CITY OF ALBUQUERQUE

**RE: Mountainside Church Addition
Grading and Drainage Plan
Engineer's Stamp Date: 09/14/18
Hydrology File: J22D068**

GRADING AND DRAINAGE PLAN

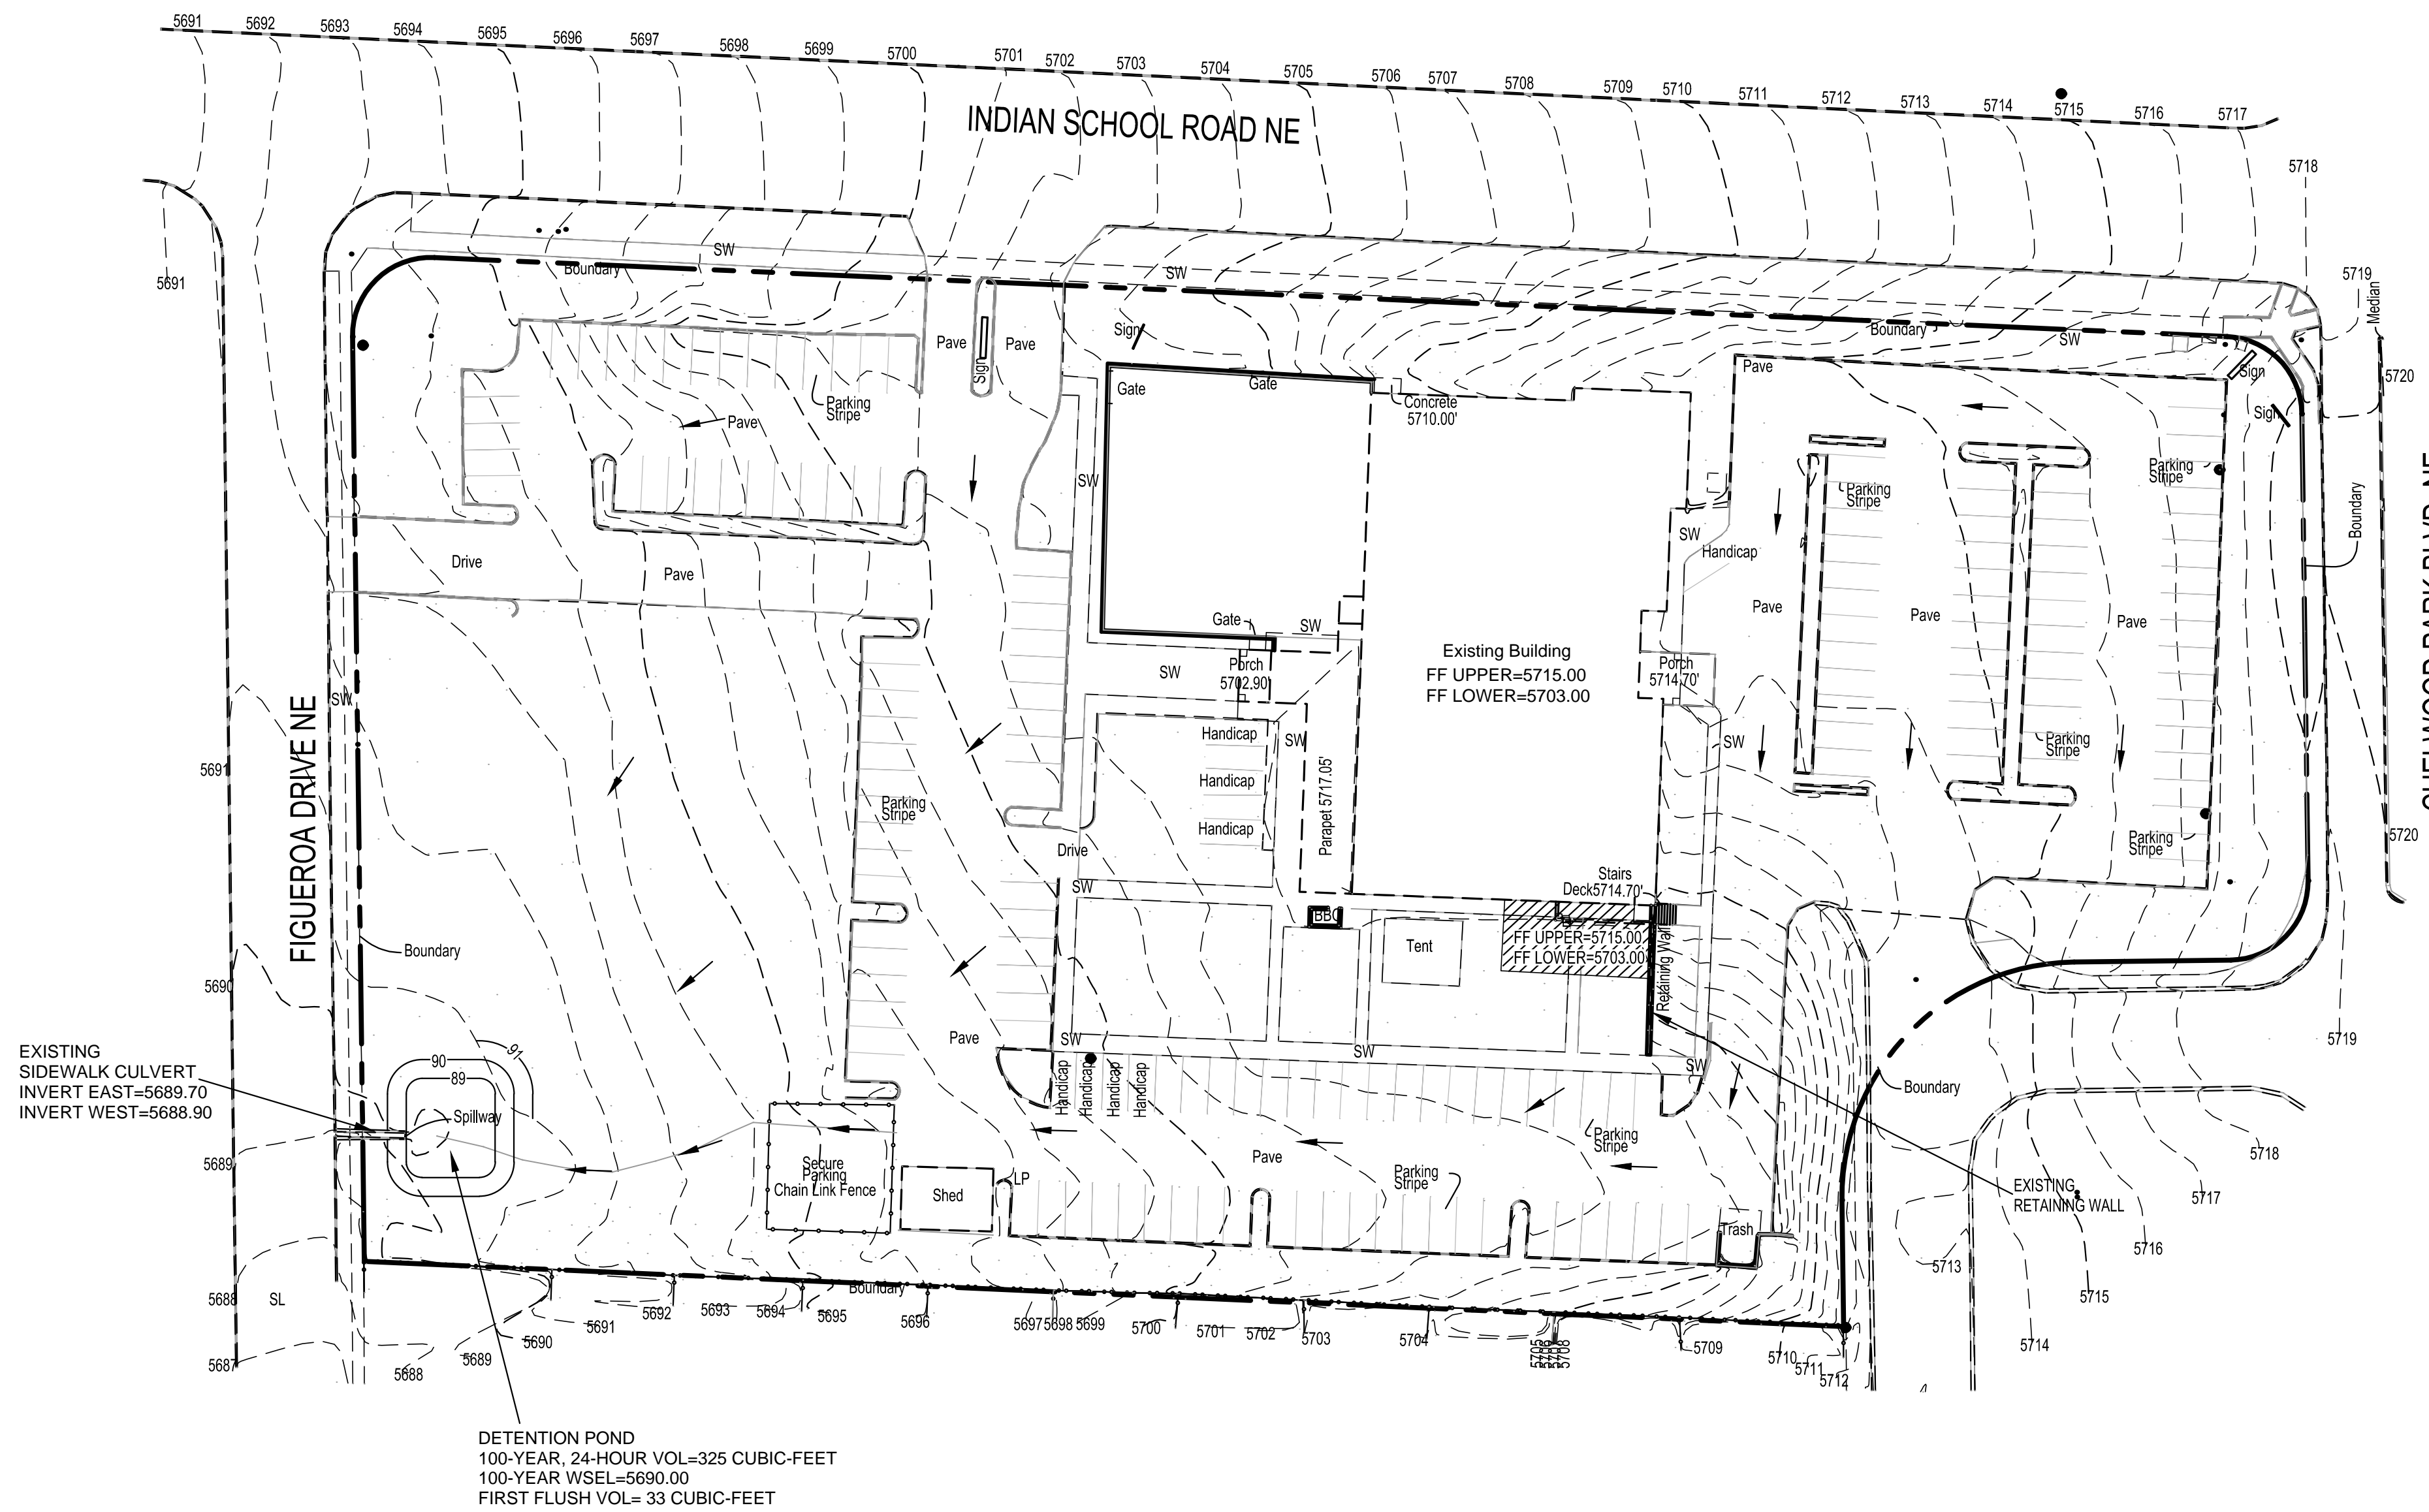
Based upon the information provided in your revised submittal received 09/20/2018, the Grading and Drainage Plan is approved for Building Permit.

Please attach a copy of this approved plan in the construction sets for Building Permit processing along with a copy of this letter. Prior to approval in support of Permanent Release of Occupancy by Hydrology, Engineer Certification per the DPM checklist will be required.

Please provide a Private Facility Drainage Covenant per Chapter 17 of the DPM for first flush pond prior to Permanent Release of Occupancy. Please submit this on the 4th floor of Plaza de Sol. A \$25 fee will be required.
